**WHITE LAKE TOWNSHIP
INTER-OFFICE MEMORANDUM
COMMUNITY DEVELOPMENT DEPARTMENT**

**SUBJECT: Lasting Impressions Landscaping
Preliminary site plan approval**
Property described as parcel number 12-01-127-002, located on the north side of White Lake Road, west of Old White Lake Road, consisting of approximately 2 acres.
Request: Preliminary site plan and special land use approvals
Applicant: Kieft Engineering

RE: Lasting Impressions Outdoor Services - Preliminary Site Plan Review- 2nd Review

TO: Sean O’Neil, Community Development Director
FROM: Matteo Passalacqua, Associate Planner
DATE: July 8, 2024
RE: Lasting Impressions PSP / SLU Review

SCALE: 1" = 30'
SHEET NO: V1.01
KE 2023.104

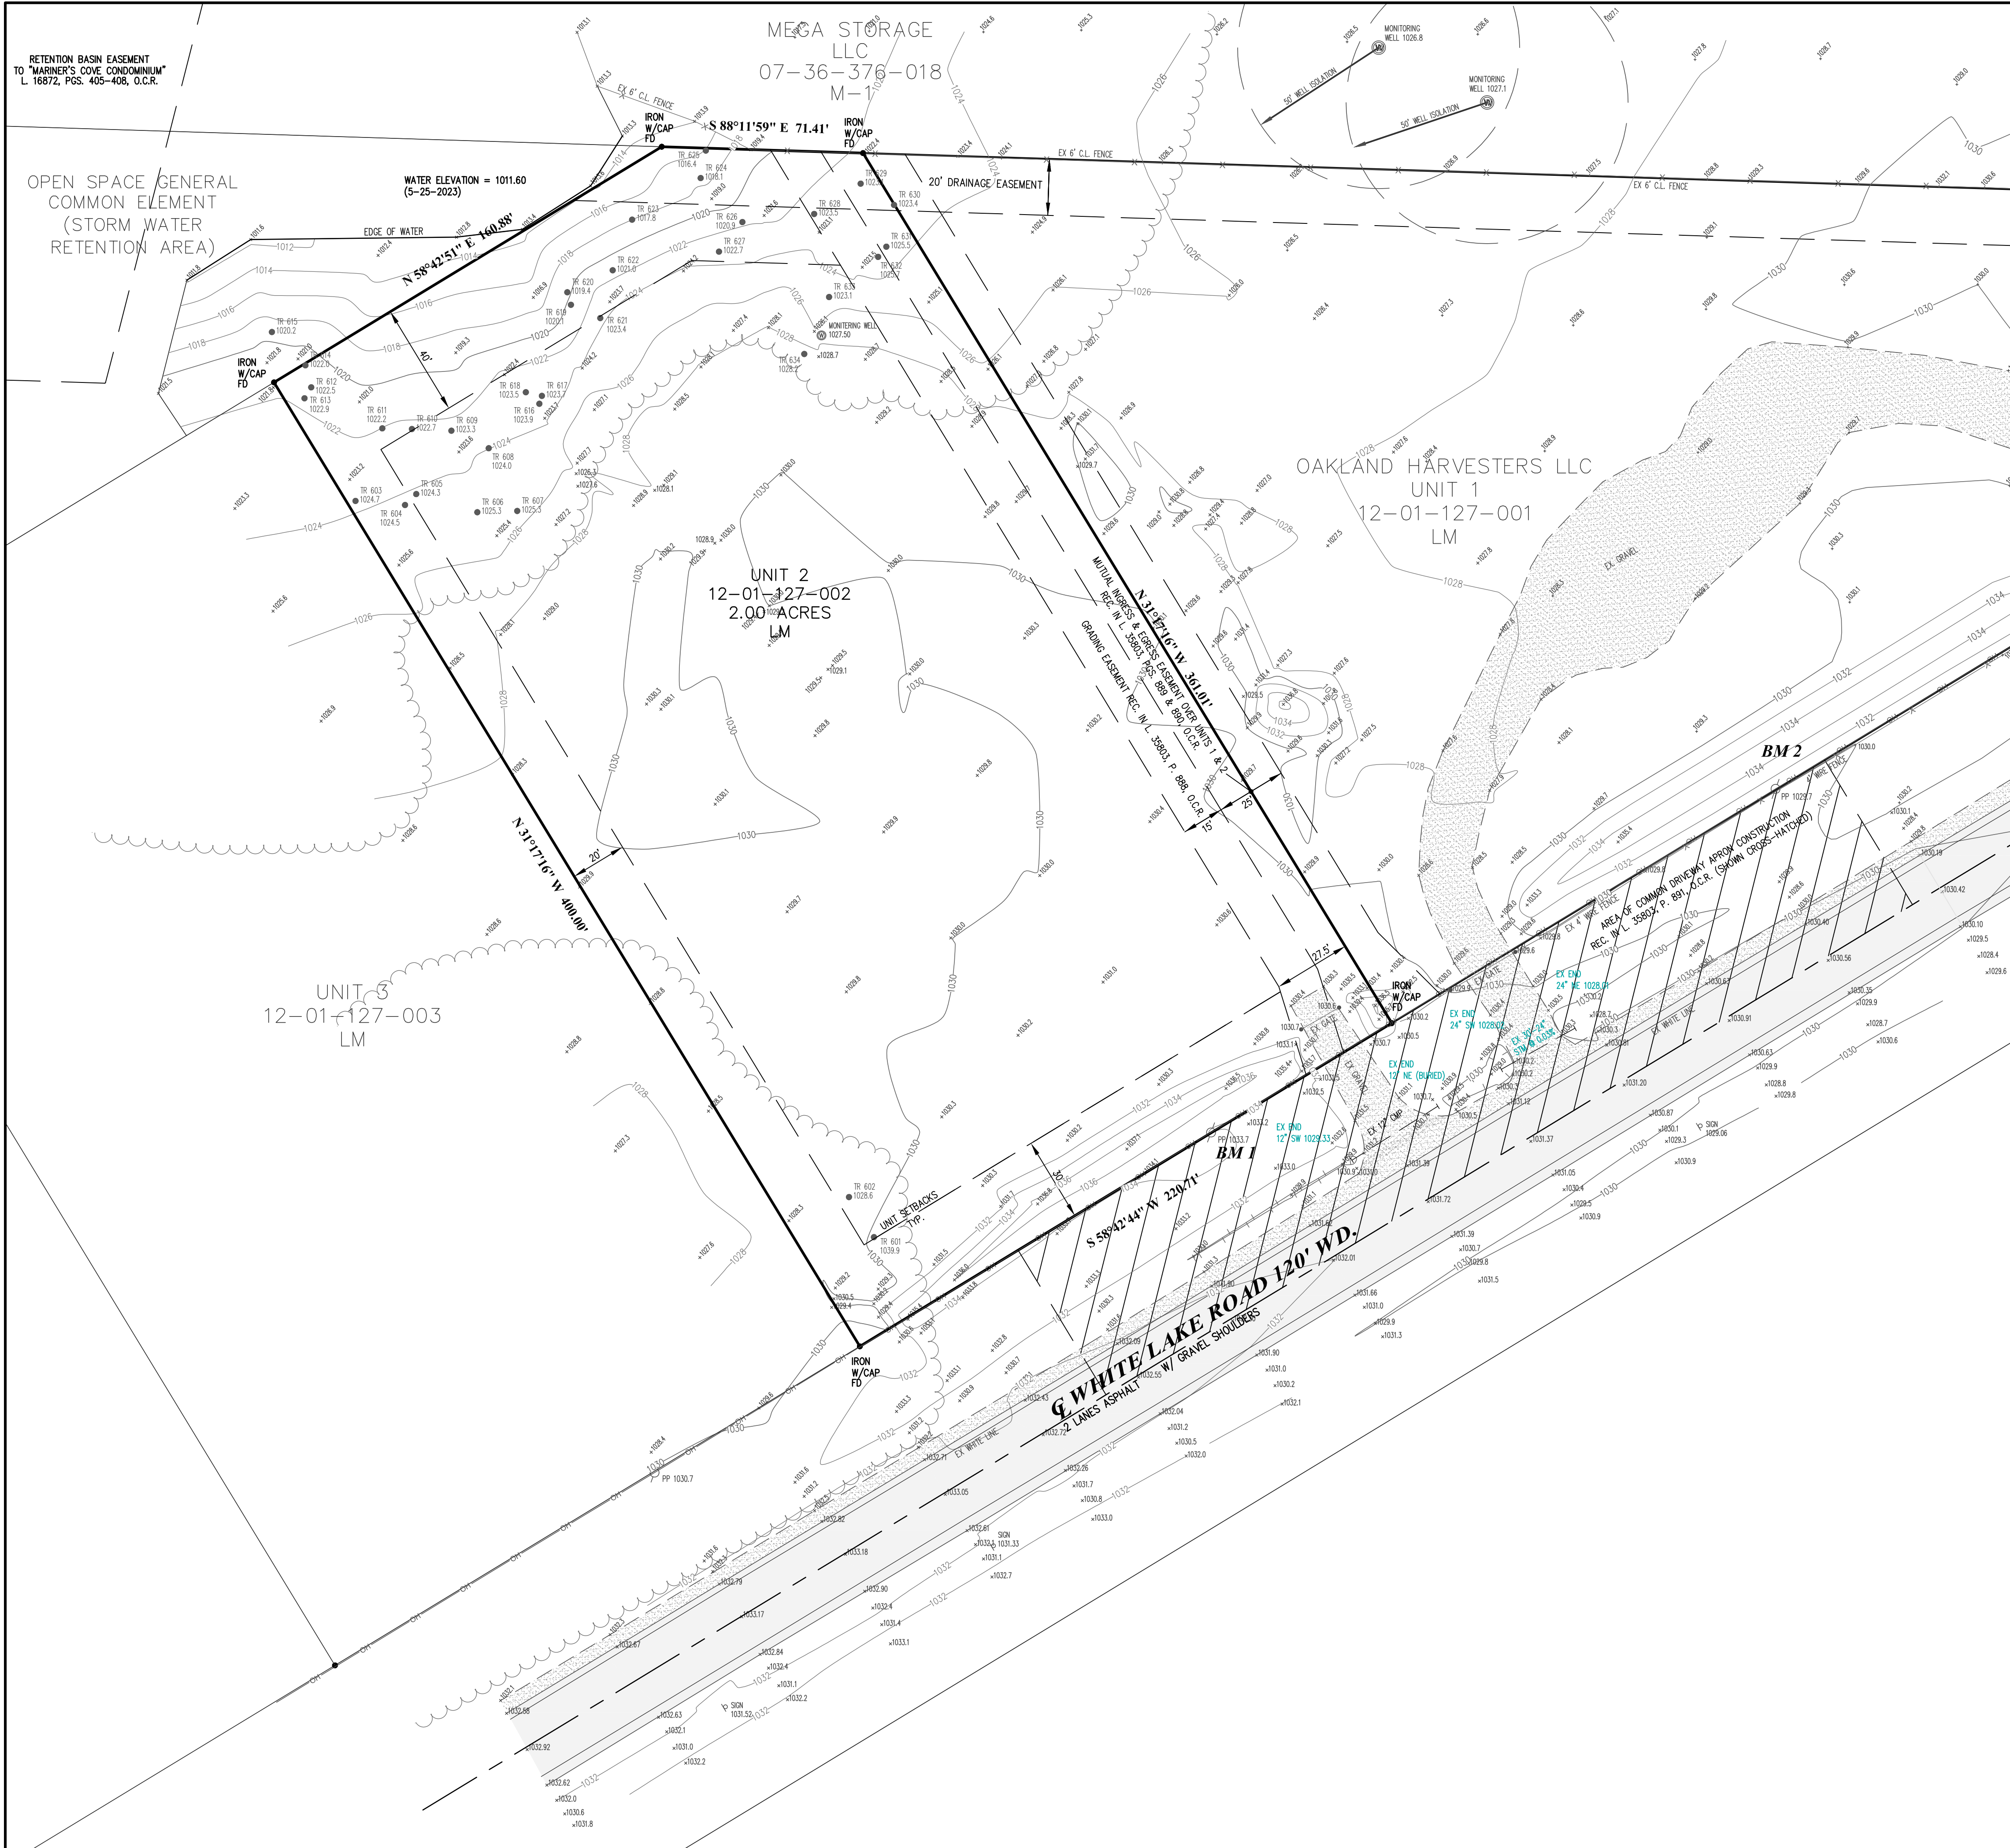
3. *Sheet V1.01- List additional benchmark (BM 2) on this sheet. Please reference Sheet C1.01.* **Comment addressed. BM2 has now been shown on this sheet.**

Table with 2 columns: SCALE, SHEET NO. Includes values NONE and C0.01.

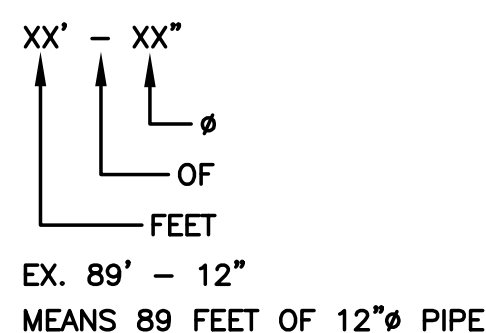
4. *Sheet C0.01- Utilities notes- Item 1- Revise minimum cover to the following: a) Water- 6.0' except at GV's which are 5.5'; b) Sanitary Sewers- 4.0'; All Others (Storm Sewer)- 3.5'-5.0' measured from rim to top of pipe.* **Comment addressed. Minimum cover depths have been updated.**

5. *Sheet C.0.01- Utilities notes- Item 6- Provide sheet reference number if underdrain is proposed and provide a detail.* **Comment remains. Design engineer states that sheet reference will be filled in on the final engineering plan set.**

SCALE: 1" = 30'
SHEET NO: C1.01
KE 2023.104

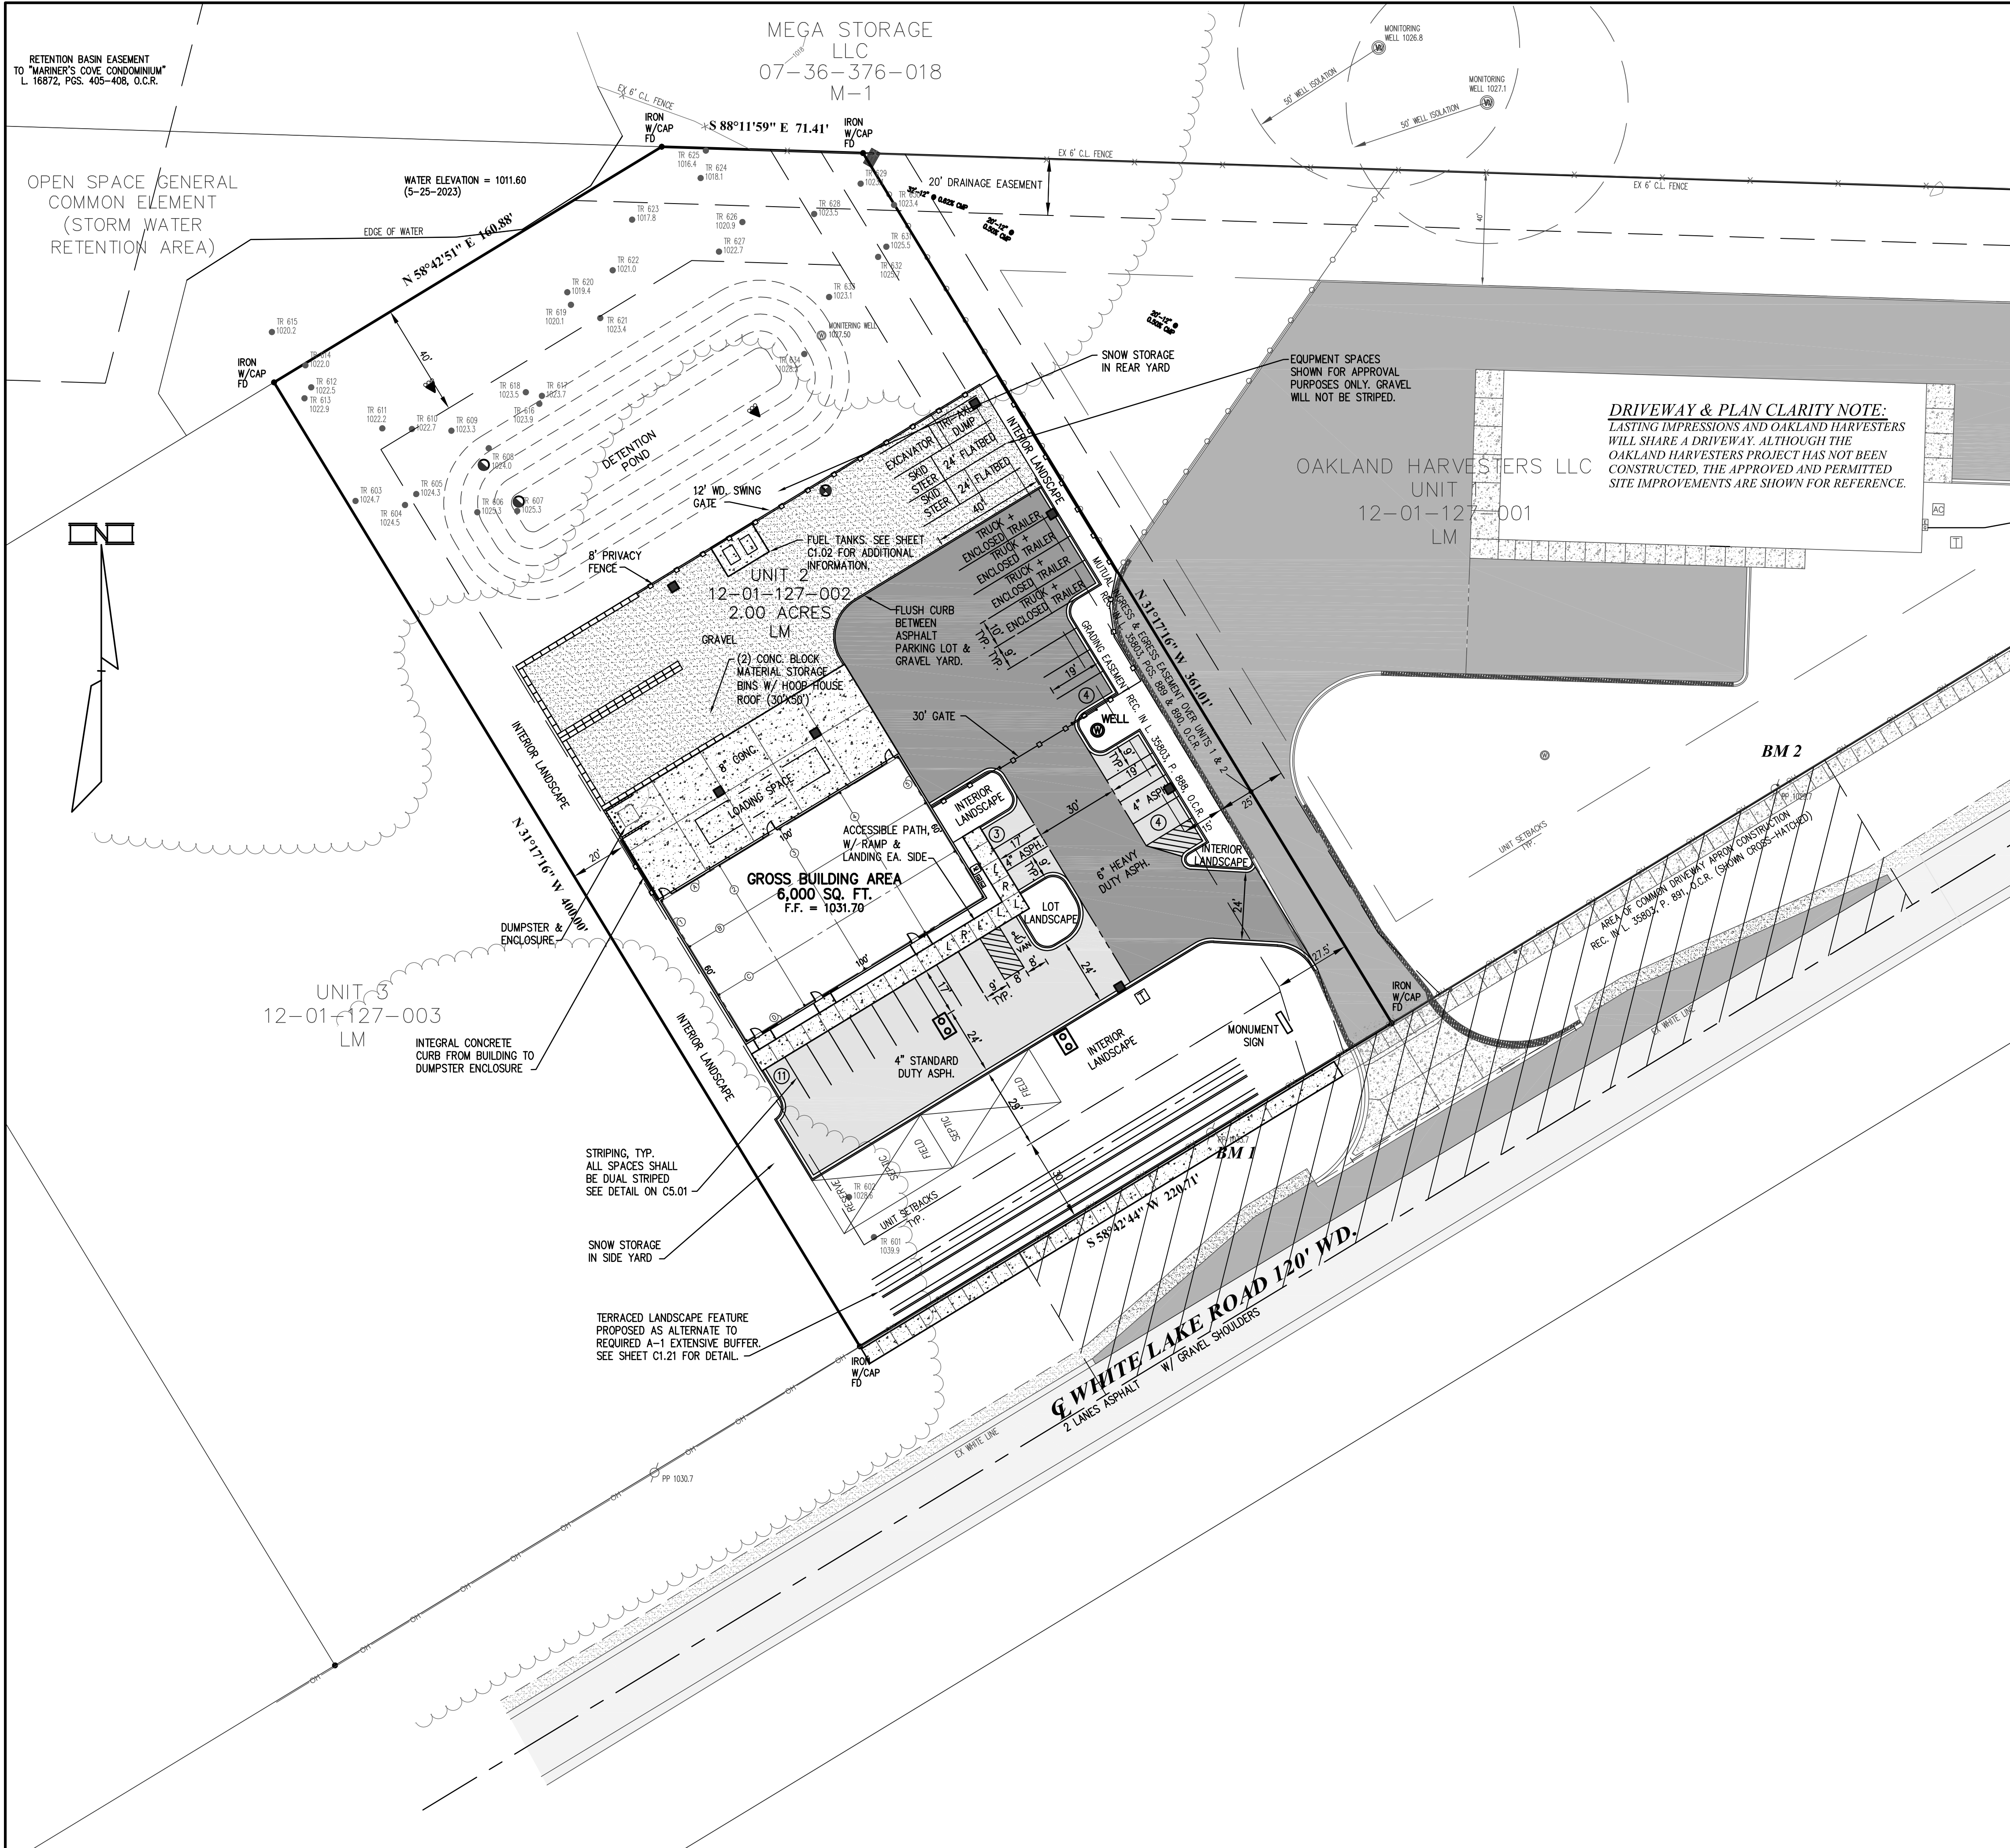
6. *Sheet C1.01- Per Township Zoning Ordinance 5.11.O.iii., at least one ADA parking space shall be van accessible with an 8' wide adjacent loading space. Currently a 5' wide loading space is shown adjacent to the ADA van accessible space. **Comment addressed. The ADA loading space is now shown as 8' wide.***

7. *Sheet C1.01- Provide dimensions for the four (4) parking spaces adjacent to the truck and enclosed trailer parking. **Comment addressed. Dimensions have been provided.***
-

8. *Sheet C1.01- Label the surfacing material for the northern storage area and excavator/ skid steer parking area as gravel on this plan sheet. **Comment addressed. Surfacing material has now been specified.***
9. *Sheet C1.01- Is curbing intended for the area to the west of the proposed loading space? Plan is not clear as to whether curbing is shown here. Curbing shall be required for this area. **Comment addressed. A call-out has been added to this sheet indicating curbing in the above referenced area.***

We note only one area on Sheet C1.01 indicates "lot landscape" and no square footage for the area is provided. A note under the "REQUIRED PARKING LOT LANDSCAPING PER ZO SECTION 5.19G" states 363 square feet of parking lot landscaping is provided. The title for the area on the Sheet should be retitled "Parking Lot Landscape" to correlate between the map title and corresponding notes.

Snow storage information has been added to Sheet C1.01. The front lot will store snow in the west side yard. Rear and side lot snow will be stored in the rear yard. It should be considered that storage of snow in the side yard has the potential to spill into neighboring properties either during freeze or thaw conditions. We propose consideration of retaining all snow storage to the rear yard location.
